Section 16 Planning Application for Proposed Amendments to an Approved Comprehensive Residential Development Scheme and Minor Relaxation of Gross Floor Area and Building Height Restrictions at Various Lots in D.D. 385 and Adjoining Government Land, Tai Lam Chung, Tuen Mun (Application No. A/TM-SKW/134)

Response to Departmental Comments

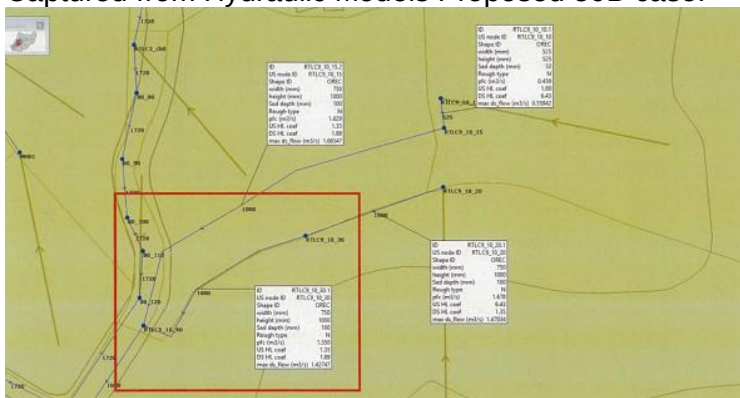
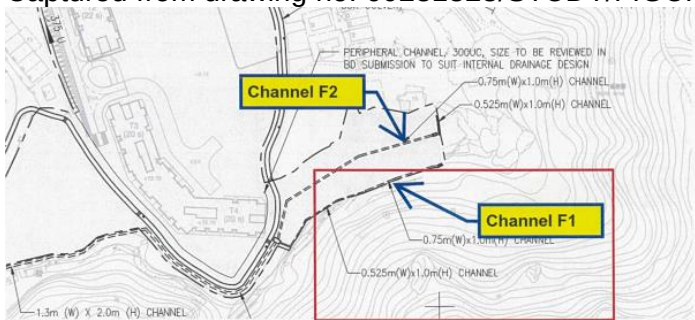
4.2	It is noted that there are changes in alignments of the proposed drainage facilities and addition of a u-channel proposed to be maintained by DO on the revised Drainage Maintenance Arrangement Plan at Figure 7 of the revised Drainage Impact Assessment (DIA), as compared to the original Drainage Maintenance Arrangement Plan agreed by DSD and DO(TM) in 2023 for the land exchange for proposed TMTL 417 under processing (relevant correspondences are at Annex I). Both plans are extracted at Annex II for reference. The Applicant should seek agreement from DSD and DO(TM) on the proposed revised design and maintenance arrangement.	Noted. The revised DIA including the revised drainage maintenance arrangement plan has been circulated to DSD and DO(TM) for comments.

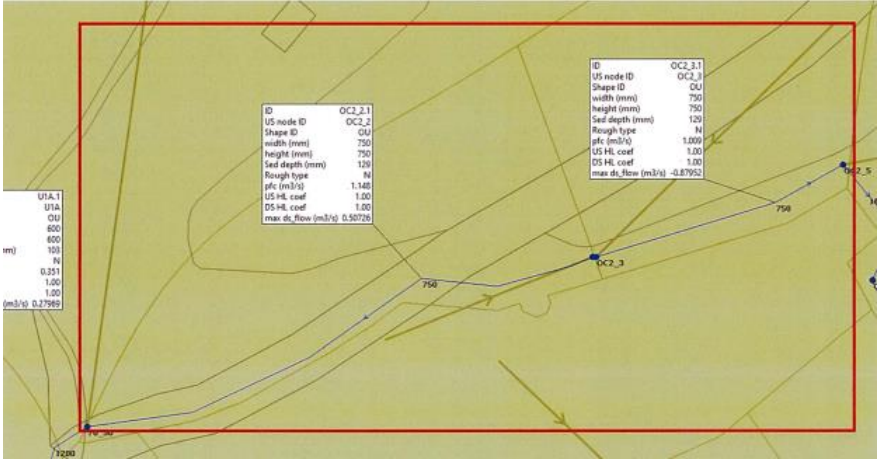
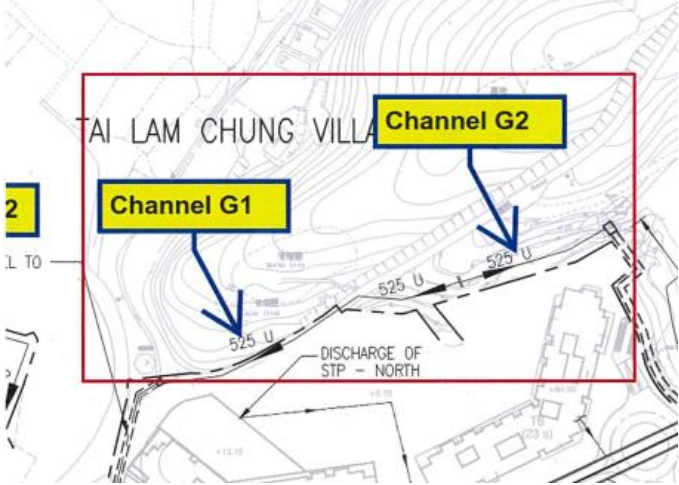
5.2	As mentioned in the previous batch of comments conveyed to you, T6 and the house cluster are adjacent to an area zoned “Green Belt”, while the unique configuration of the East Wing is acknowledged, buffer and/or other measures such as landscape treatments/setback should be provided to allow adequate separation and alleviate the impacts towards the neighbouring woodland and Tai Lam Country Park.	To respect the adjacent Green Belt zoning, the following additional measures have been proposed to create a harmonious transition between the Proposed Development and the surrounding natural terrain along the boundary of East Wing Extension: • A 1.5m-wide buffer strip with tree planting is provided where maintenance access is feasible, including the northern boundary of Tower 7, Houses H3, H7–H10; the eastern boundary of Tower 6, H11–H13; and the southern boundary of H15–H17; • In areas with space constraints or difficult maintenance access, a narrower 0.6m buffer with shrub planting is proposed. Please refer to revised Landscape Master Plan and Landscape Sections under Attachment 2 for illustration.

5.3	It is noted that the slope with trees near T7 forms part of the Development Site, please clarify if the tree survey conducted has taken in account the existing tree cluster along the slope.	All existing trees with a DBH over 95mm near Tower T7 and within the Application Site were included in the tree survey. For trees growing on slopes outside the Application Site, separate submissions to the relevant departments under lease will be made if they are impacted in the future, if any.

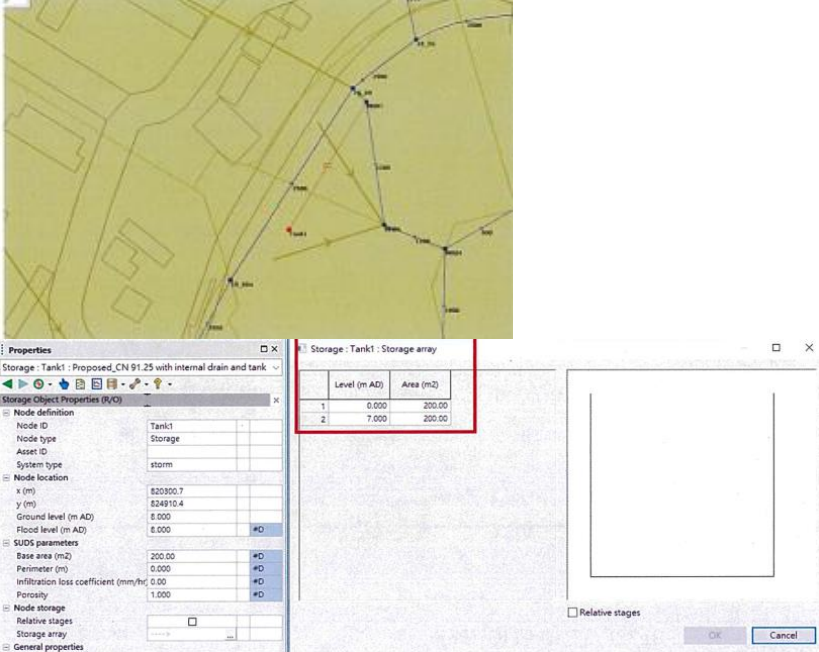
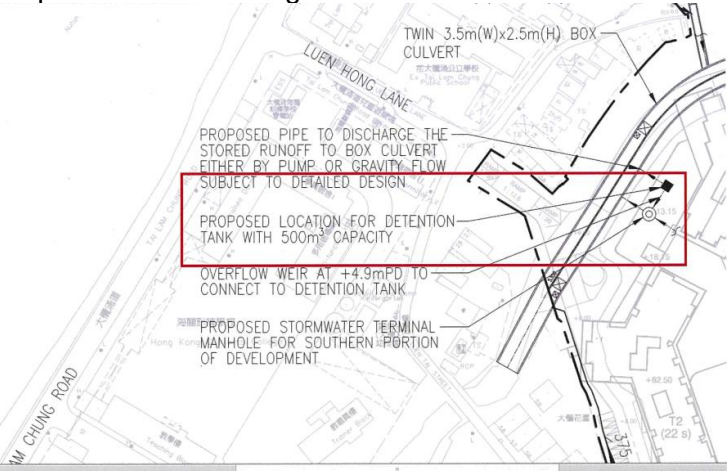
7.5	<u>Detailed/Advisory Comments</u> Paras 4.1.5 of the Revised AVA-EE & Para. 4.2.3 of the Replacement Pages of the Planning Statement – Having reviewed the relevant analyses and discussions, the conclusion of the AVA-EE should read “the Proposed Scheme/Development <u>would not have significant air ventilation impacts</u> on the pedestrian wind environment compared to the Baseline Scheme” instead of “<u>acceptable</u> in terms of air ventilation/in air ventilation terms”. Notwithstanding this, the comments above remain generally applicable.	Noted. Para. 4.1.5 of the AVA-EE and Para. 4.2.3 of the Planning Statement have been revised accordingly. Please refer to the replacement pages of AVA-EE and Planning Statement under Attachments 3 and 4 respectively.

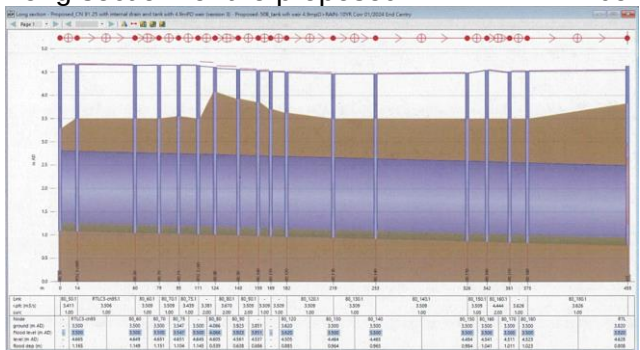
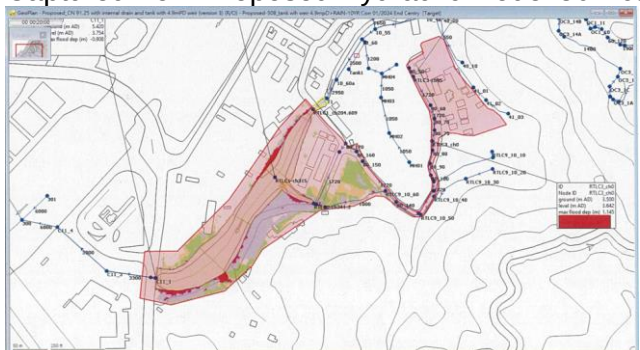
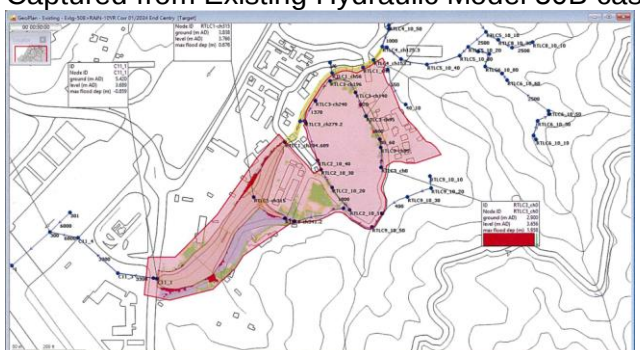
8.3	Section 6.1.3 and Figure 7 - Other than the proposed 2.5m(W) x 2.5m(H) twin box culvert (BC), there were other drainage facilities which proposed to be maintained by DSD located within/in close proximity to the development boundary, e.g. 2.20m(W) x 1.72m(H) BC at the south. The respective Drainage Reserve should also be provided. Please review the section accordingly.	The alignment of the proposed 2.20m(W) x 1.72m(H) box culvert has been revised in accordance with the email discussion with DSD for detailed maintenance arrangement for the concerned box culvert in October 2023 and subsequent maintenance arrangement plan as agreed with DSD (Letter ref. VPPW:TMCY:wtsk:60281828-2023016671L dated 20 October 2023). The email record regarding the discussion on the detailed maintenance arrangement for the concerned box culvert has also already been included in Annex A of the letter, which is enclosed in Appendix F of the submitted DIA. Therefore, drainage reserve is not required for maintenance of the concerned box culvert.
